**ADDENDUM
NO. 4**

October 18, 2024

**Whiteland High School Ph 2: Café Kitchen Band Choir Auditorium
300 E. Main Street
Whiteland, IN 46184**

5 TYP PARAPET @ EXT BRICK ON CMU
SCALE: 1" = 1'-0"

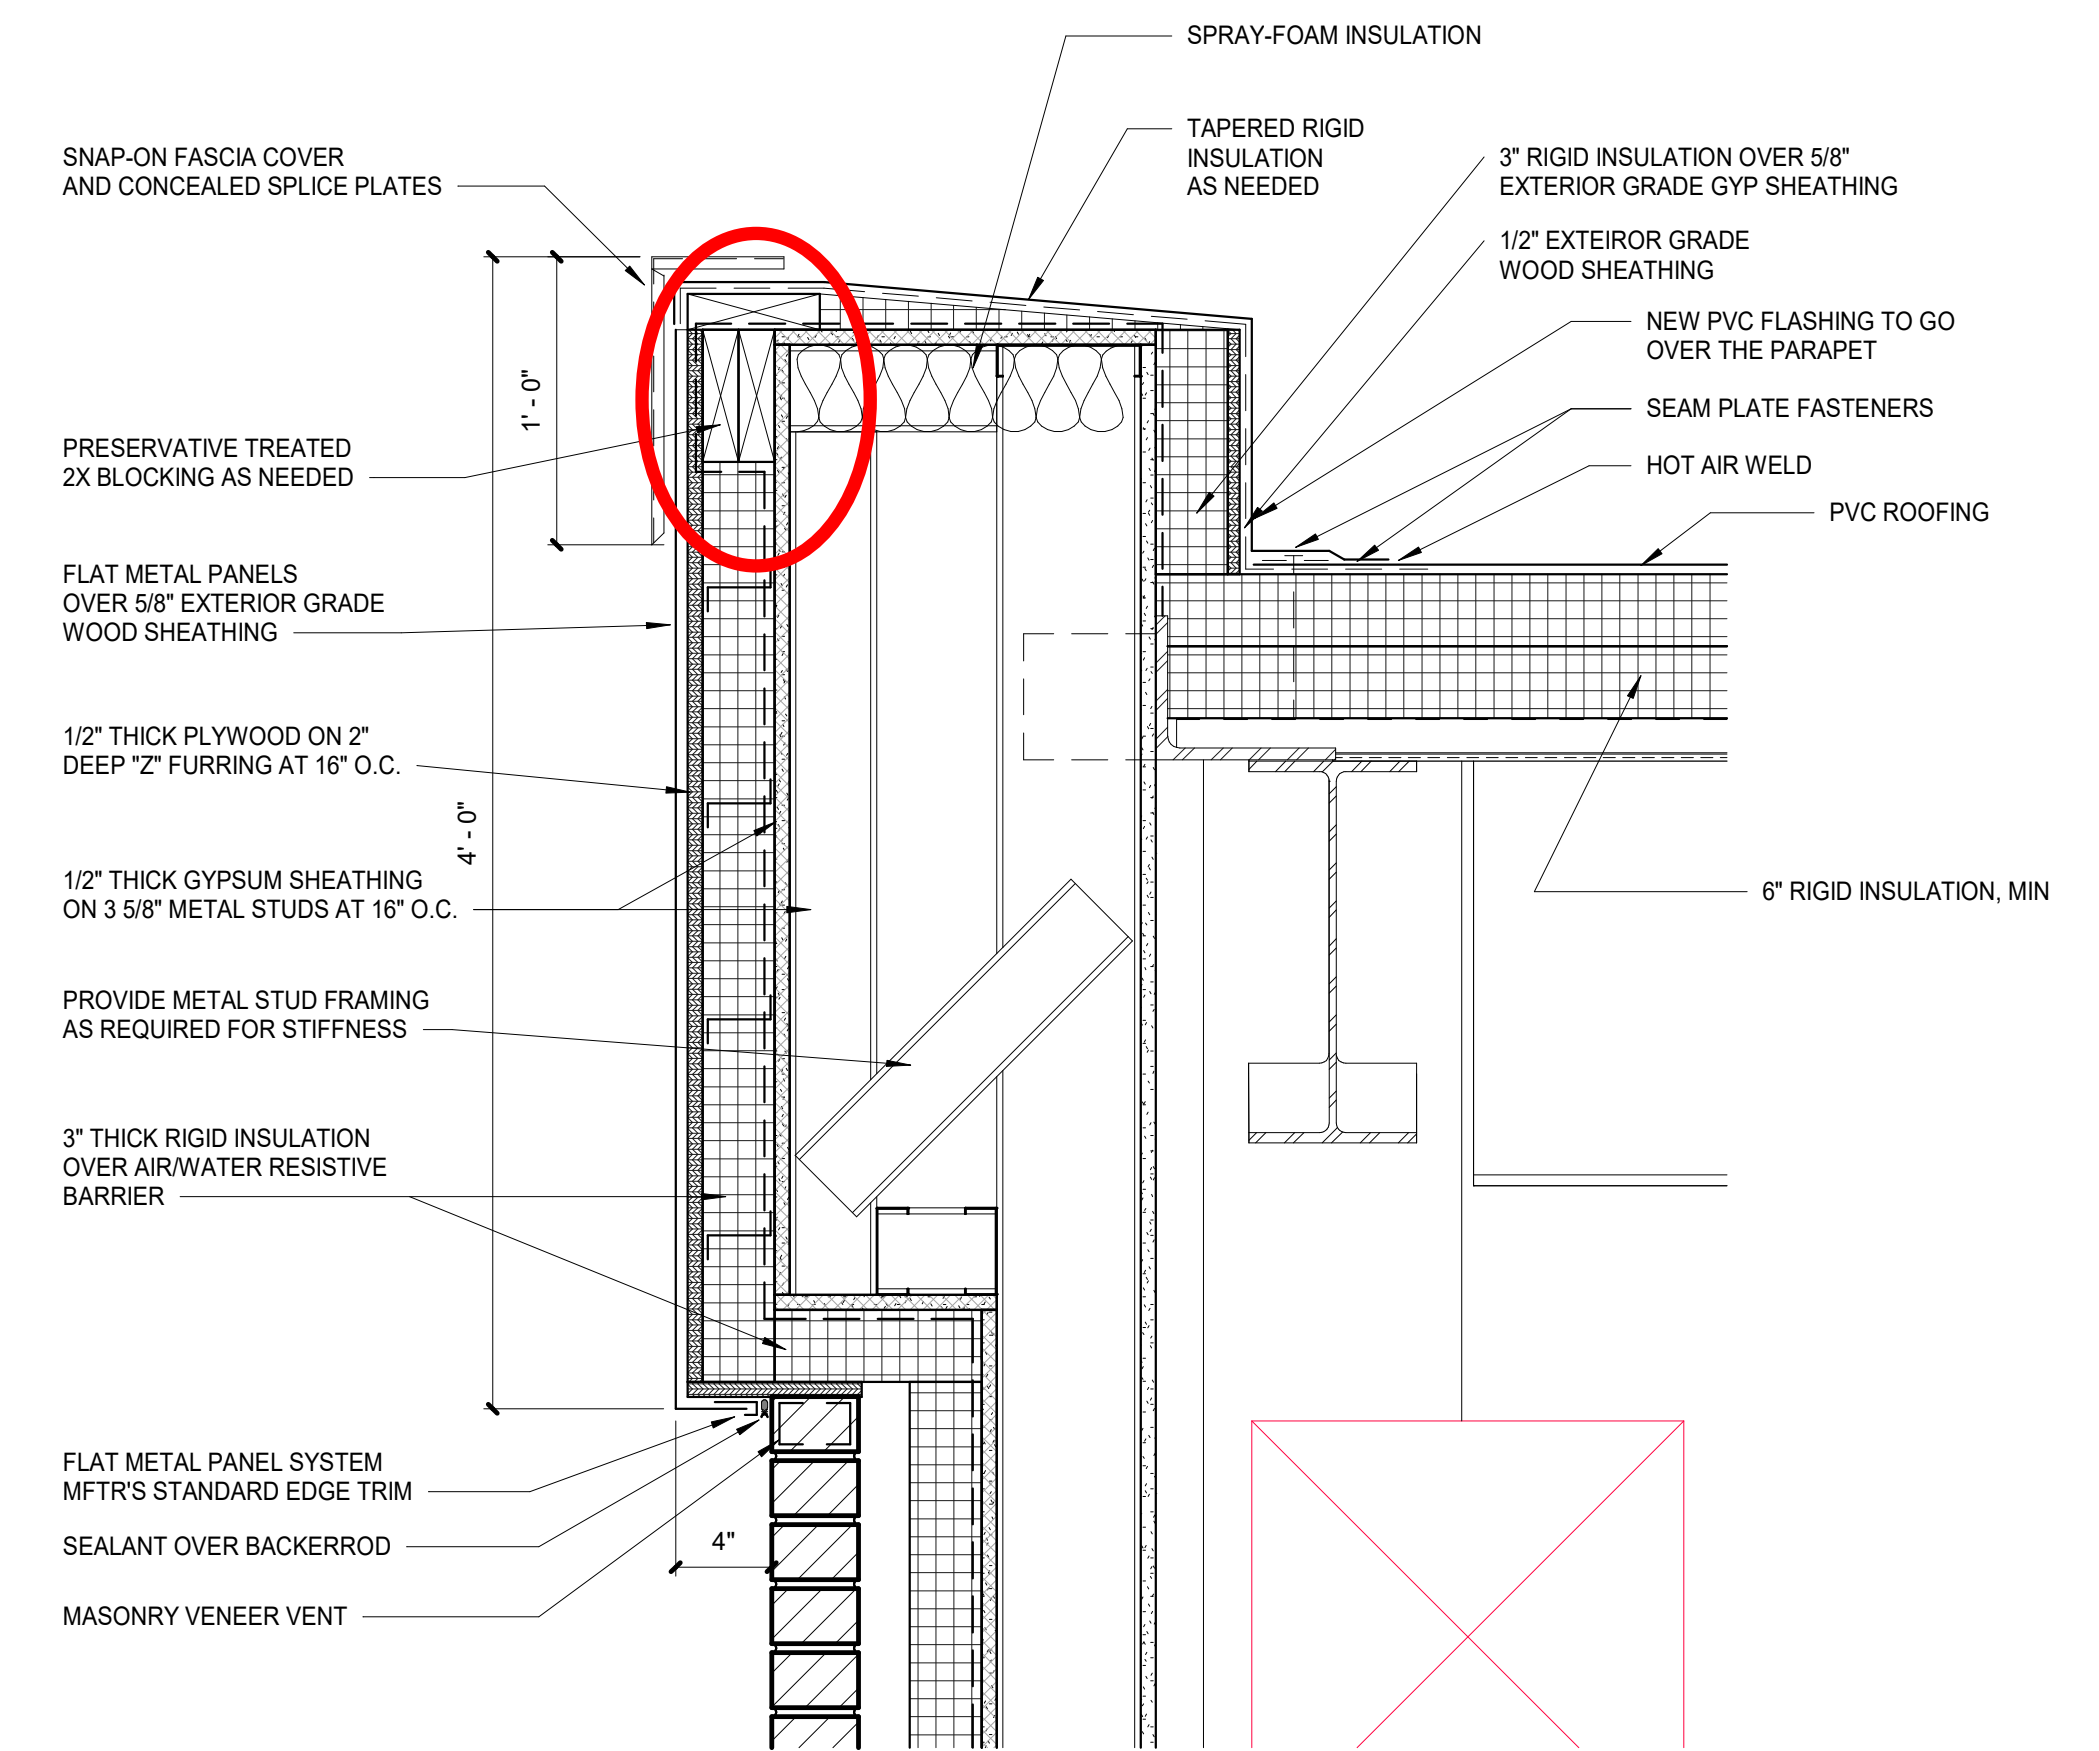
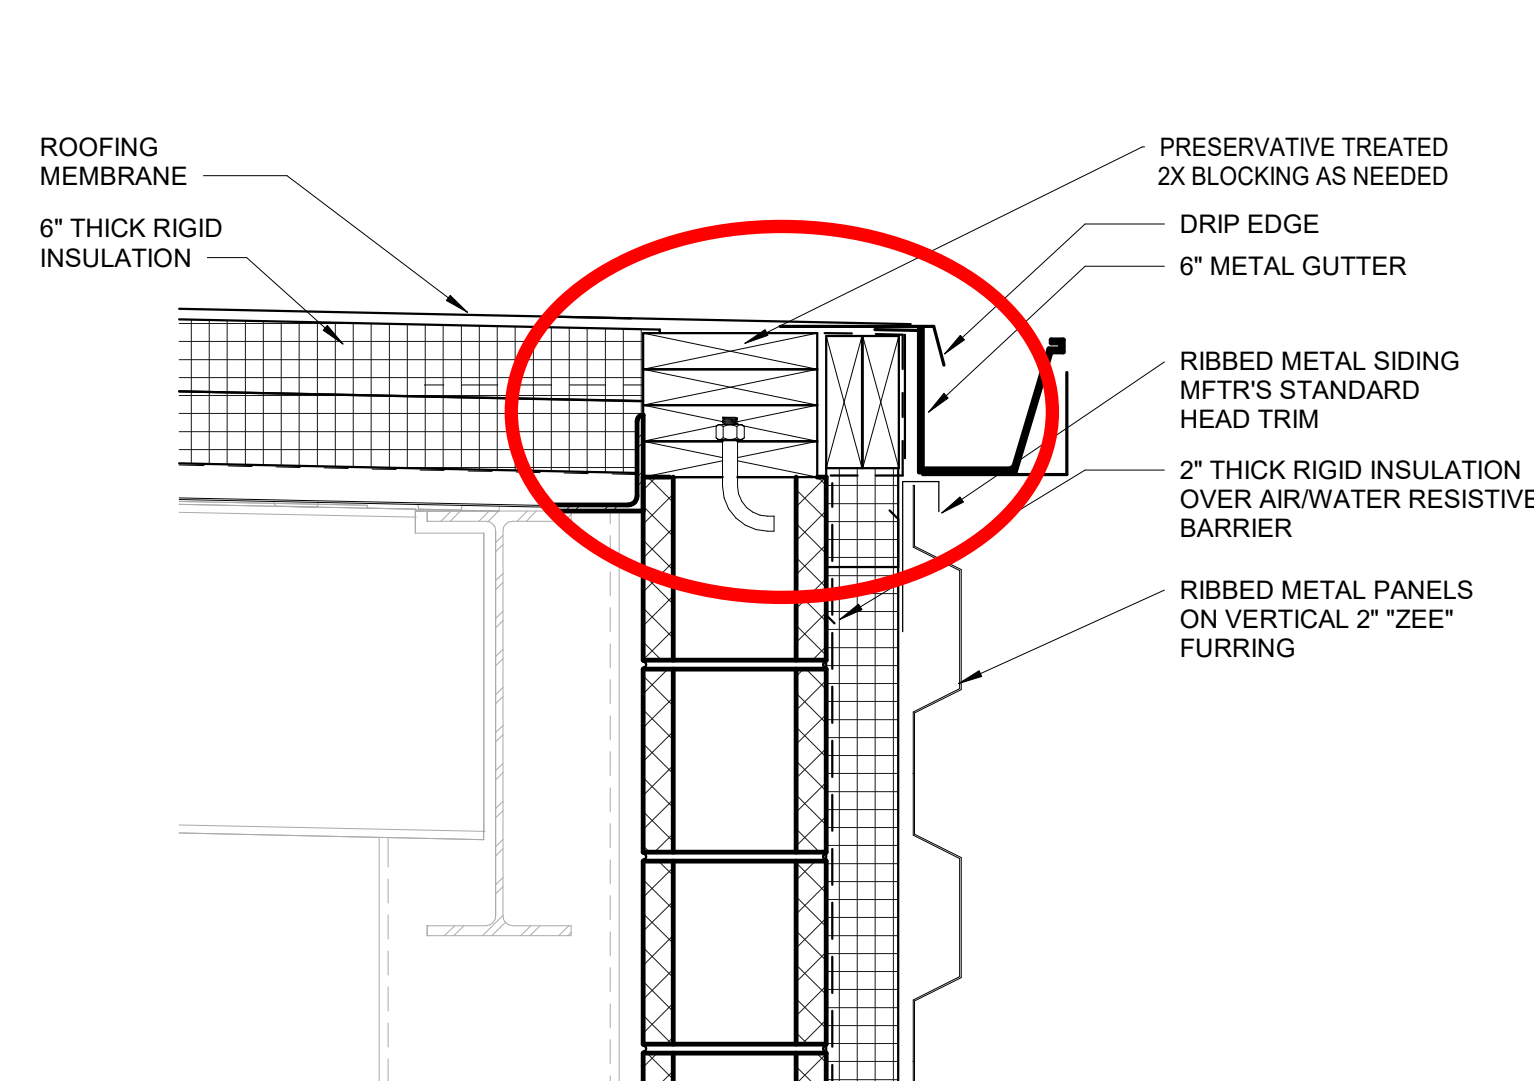
7. Bid Category No. 5 – Metal Studs, Drywall, and Acoustical Contractor is responsible for any board insulation behind metal panels that include Z-Girt installation.
8. Bid Category No. 5 – Metal Studs, Drywall, and Acoustical Contractor is responsible to provide and install all required wood blocking circled in red in the attached

all blocking in question and circled in red will be the responsibility of Bid Category No. 5 Contractor
